Subject: Duke Energy Carolinas, LLC
William States Lee III Nuclear Station – Docket Nos. 52-018 and 52-019
AP1000 Combined License Application for the
William States Lee III Nuclear Station Units 1 and 2
Supplemental Partial Response to Request for Additional Information
(RAI No. 6182)
Ltr# WLG2012.03-04

- 1) Lee Nuclear Station Supplemental Partial Response to Request for Additional Information (RAI), Letter No. 100, RAI 03.07.02-001

Lee Nuclear Station Supplemental Partial Response to Request for Additional Information (RAI)

Lee Nuclear Station
Attachment 1 to Supplemental Response to
Request for Additional Information 03.07.02-001,
Westinghouse Electric Company Report
WLG-1000-S2R-803, Revision 0
William S. Lee Site Specific Seismic Evaluation Report

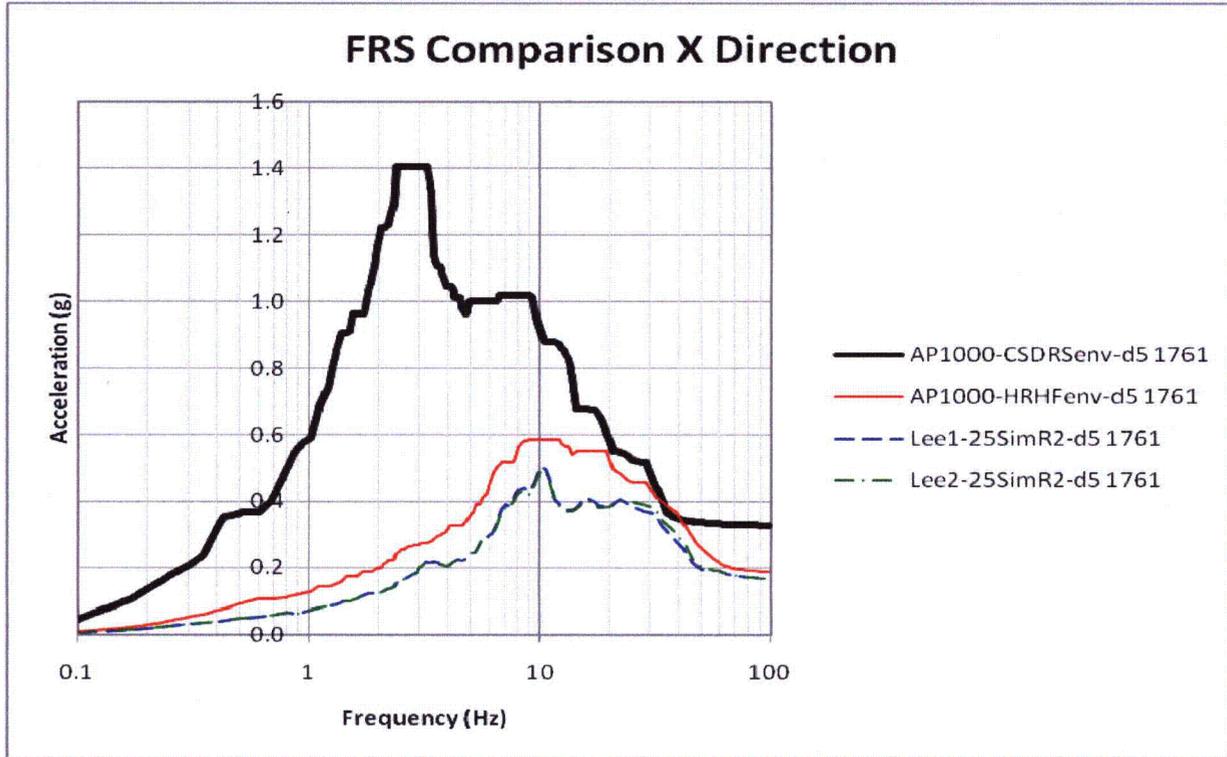
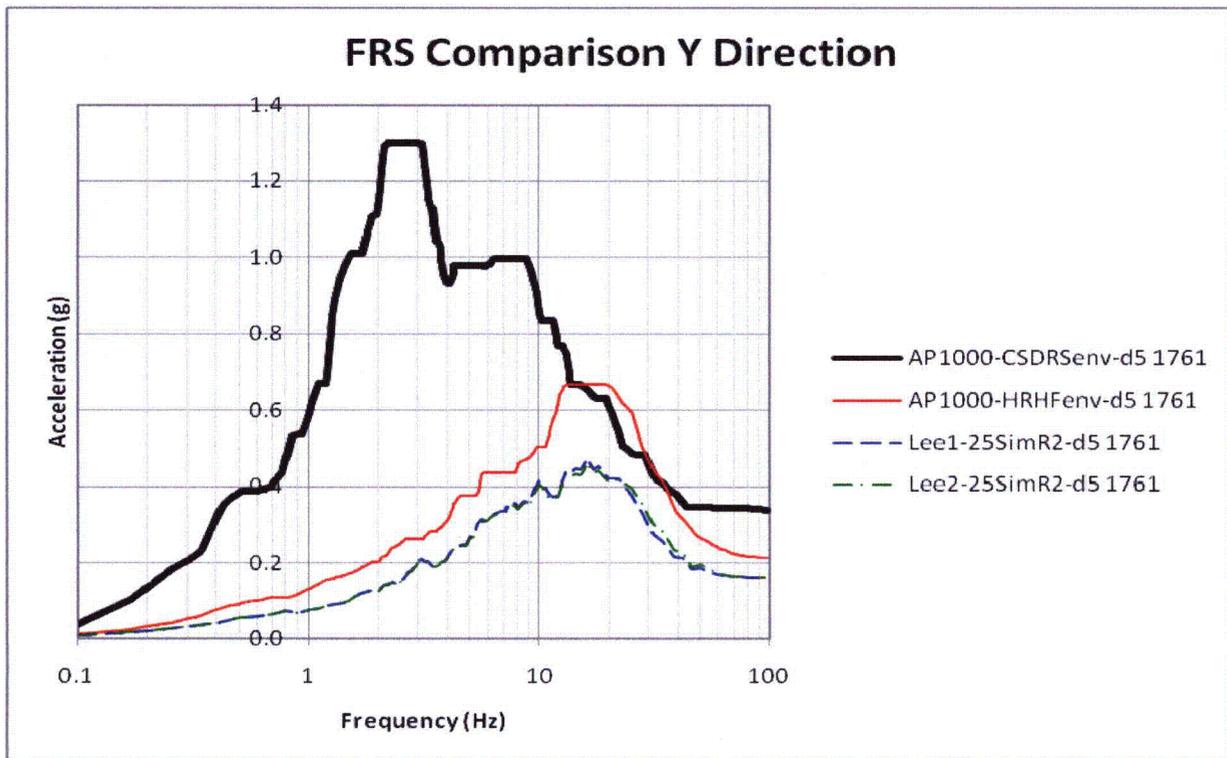
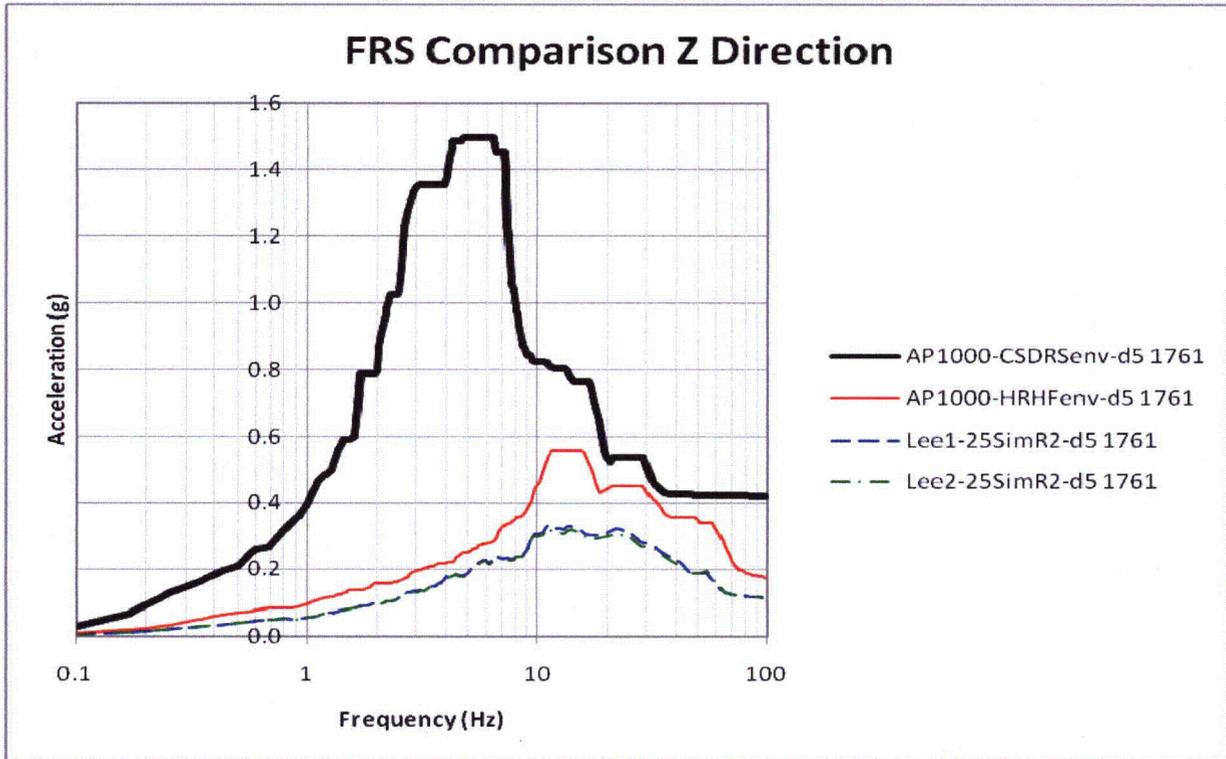
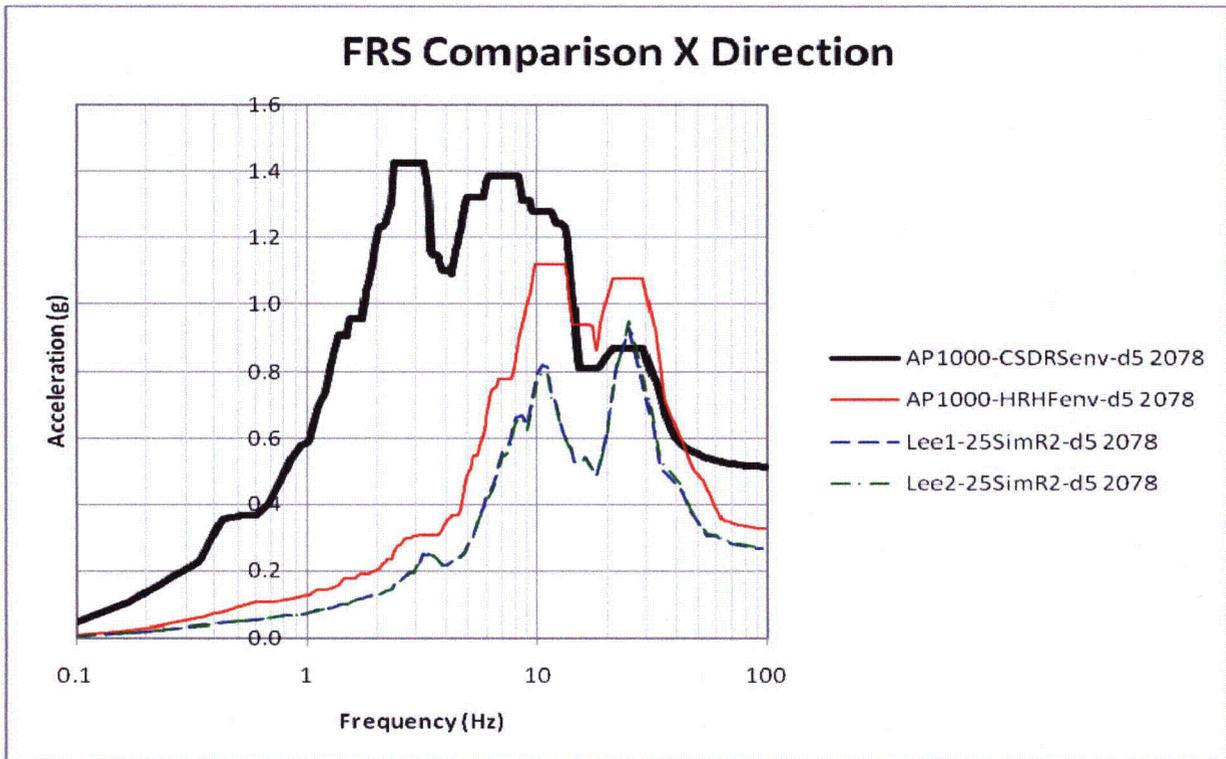
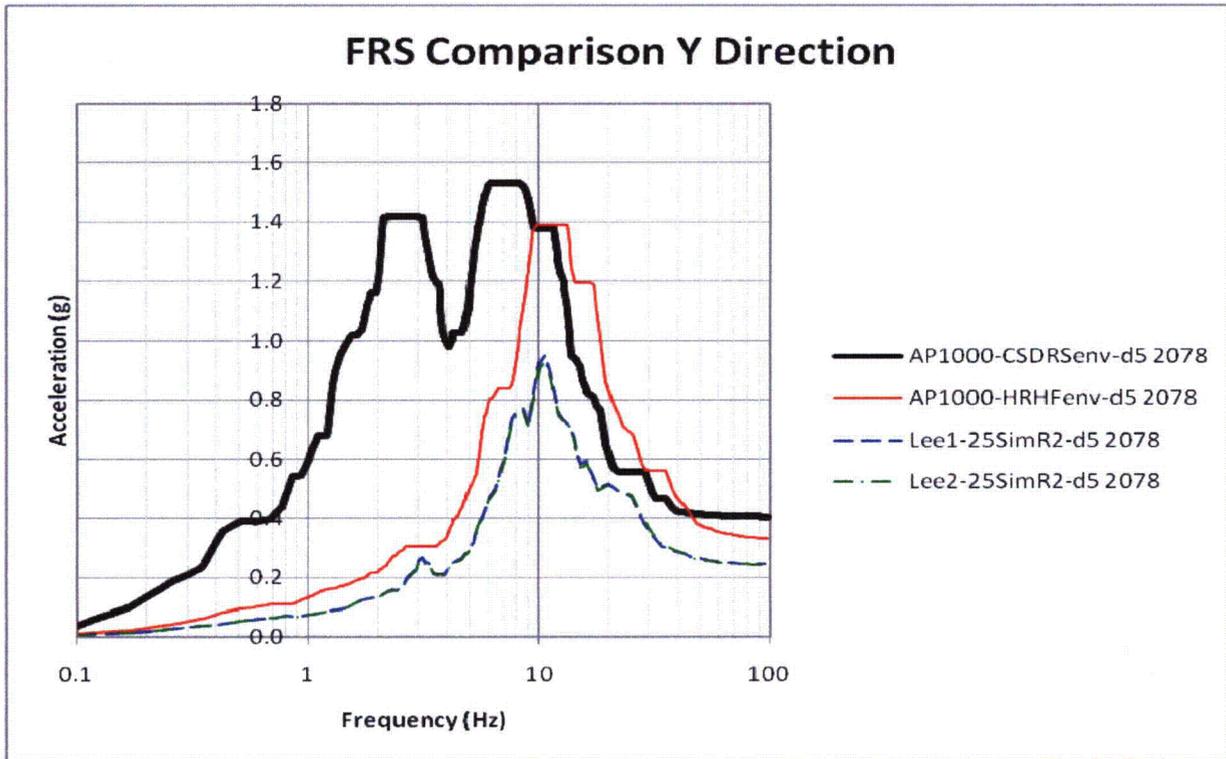
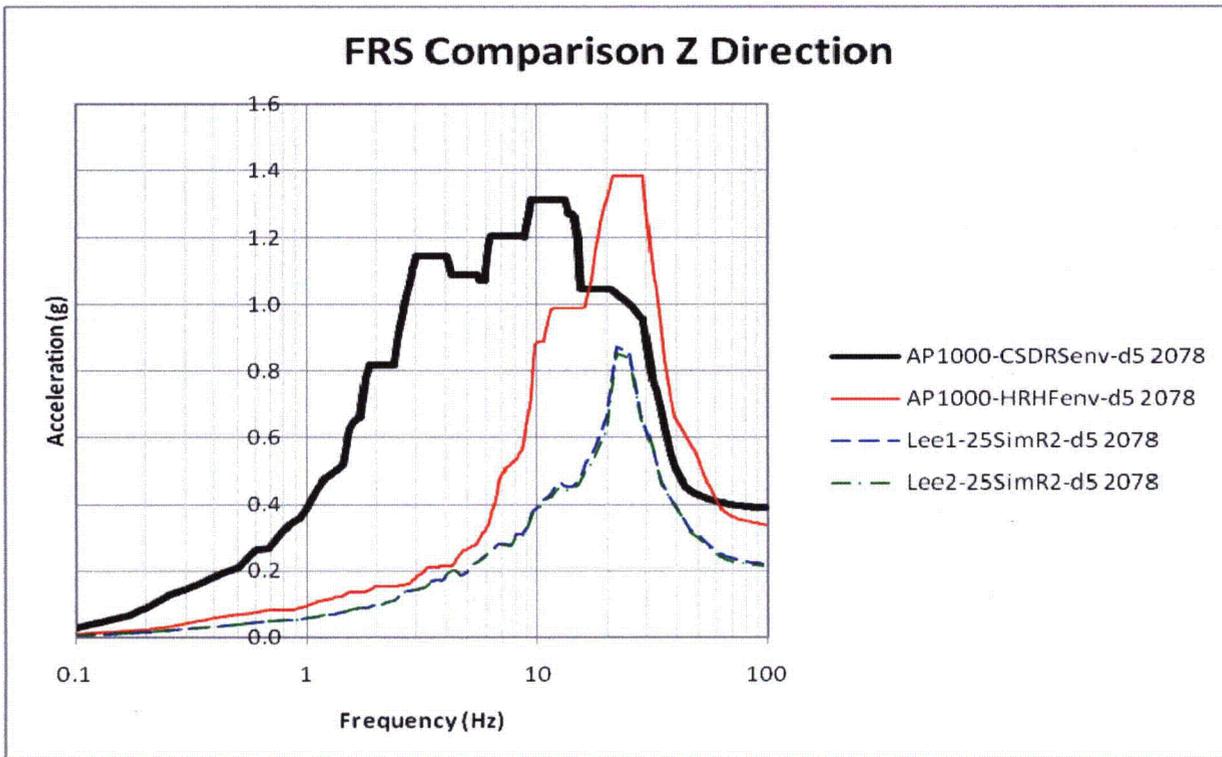
of the sensitivity study results to the standard plant design spectra (HRHF and CSDRS). If the Unit 1 seismic demands (including vertical response) exceed those of Unit 2, the applicant should justify the use of the Unit 2 profile (centerline) for the 3D SSI analysis of Unit 1.

For these 3D analyses, Lee Unit 1 and Lee Unit 2 were individually analyzed, with the first analysis using the Unit 1 centerline profile and the second using the Unit 2 centerline profile. Section 7 of Attachment 1 presents the resulting in-structure three-dimensional FRS. These spectra also represent the six key locations specified in the AP1000 DCD, and compare the site-specific FRS to the corresponding results of DCD-supporting analyses of the CSDRS and HRHF. The 3D incoherent SSI analyses also show only minor differences between Unit 1 and Unit 2, and indicate that the site-specific 3D in-structure FRS at the six key nuclear island locations are enveloped by the corresponding AP1000 CSDRS SSI envelope FRS. The results from these analyses are described in Attachment 1, and are summarized in the proposed new FSAR content in Attachments 2 and 3.

The Duke Lee Units 1 and 2 NI 3D SASSI results are shown in Figures 7-1 through 7-18. The Duke Lee Units 1 and 2 NI20r surface models were run through 25 simulations of incoherent 3D analysis using the three predefined direction-based time histories shown in Figures 3-5, 3-6 and 3-7. The Duke Lee site is classified as a hard rock high frequency site, and therefore analyzed at a high frequency range. The analysis results presented in Figures 7-1 through 7-18 indicate that the Units 1 and 2 Nuclear Island 5 percent damping FRS of an AP1000 at the Duke Lee site at the six key locations are enveloped by the AP1000 3D CSDRS and HRHF SSI envelopes.
